Project	IEEE 802.16 Broadband Wireless Access Working Group < http://ieee802.org/16 >	
Title	Data Randomization	
Date Submitted	2003-03-05	
Source(s)	Degeest Emmanuel Engels Marc Erreygers Jan LoraNet Kapeldreef 75 B-3001 Leuven, Belgium	Voice: +32 16 28 16 17 Fax: +32 16 28 86 50 emmanuel.degeest@imec.be marc.engels@imec.be jan.erreygers@imec.be
Re:	Call for contribution IEEE 802.16d-03/02	
Abstract	This contribution identifies two problems in the section on data randomization and proposes solutions therefore.	
Purpose	For inclusion in the 802.16d amendment document	
Notice	This document has been prepared to assist IEEE 802.16. It is offered as a basis for discussion and is not binding on the contributing individual(s) or organization(s). The material in this document is subject to change in form and content after further study. The contributor(s) reserve(s) the right to add, amend or withdraw material contained herein.

Data Randomization

Figure 128ada: OFDM scrambler DL initialisation vector for bursts #2..N

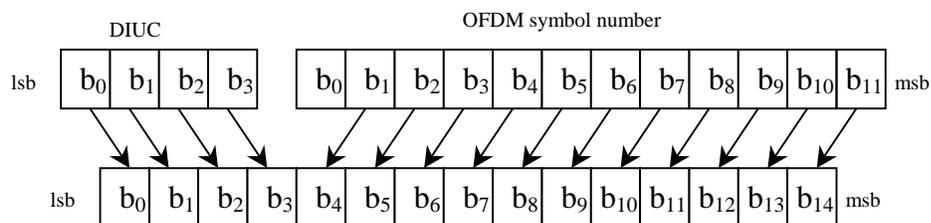
1. Section 8.4.3.1 of [1] states that data randomization is performed on each burst of data independently. This implies that the scrambler has to be reset at the start of each burst. Currently for the DL there is only an initialization vector defined at the start of each frame. To be complete, we therefore need to define an initialization vector for each data burst. To simplify the implementation (critical feedback loops) for the SSs, the scrambler should not need to be reset after the FCH. For the bursts #2...N an initialization vector similar to the one for the UL can be used.
2. For the initialization of the scrambler on the UL, it has to be defined precisely what the OFDM symbol number is. We propose to reference the symbol number to the start of the UL-subframe. The first symbol can be counted as symbol #0.

Change the last two sentences of 8.4.3.1 of [1] and add a figure:

On the DL, the scrambler shall be initialised at the start of the FCH with the vector: 1 0 0 1 0 1 0 1 0 0 0 0 0 0. The scrambler shall not be reset at the start of burst #1. At the start of subsequent bursts the scrambler shall be initialised with the vector shown in Figure 128ada. The OFDM symbol number (i.e. the number of the first OFDM symbol of the data burst) shall be counted from the start of the DL-subframe, the first symbol being counted as symbol #0.
